Special Bulletin

SP22-308A

CHANGE ORDER NO.7 - ABLE Provision. Video Plate Installation

Prevost vehicles

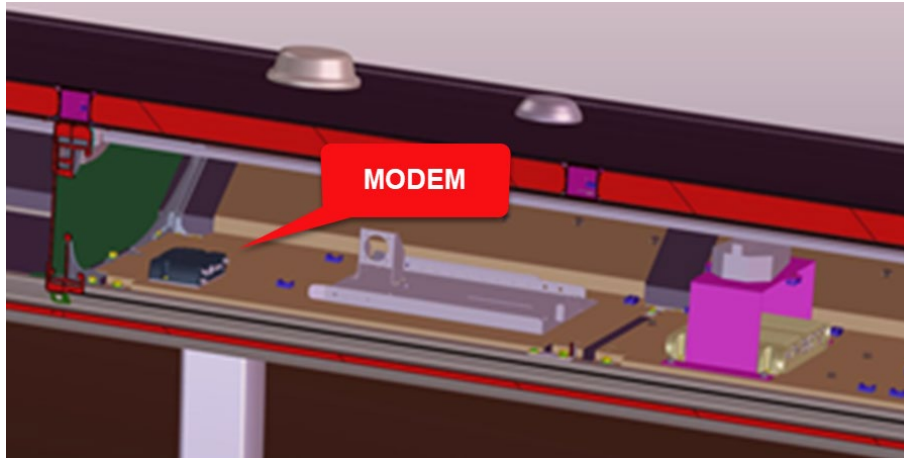
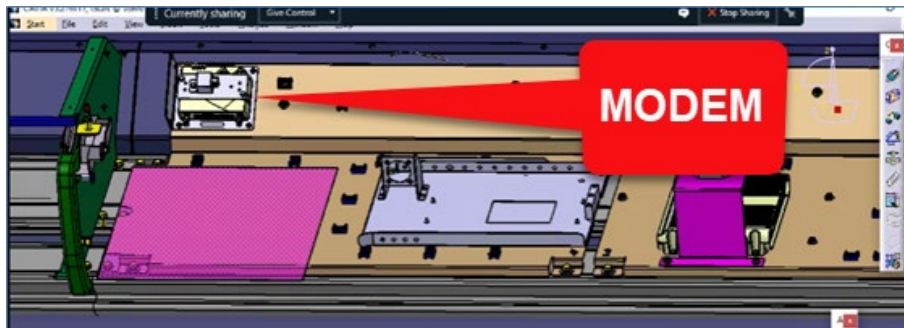
1. If proceeding on VIN 4RKJ33498M9737768, inspect first. This vehicle may have already been corrected.
2. Replace the existing video plate by new video plate 402192.

3. Relocate the modem as shown.
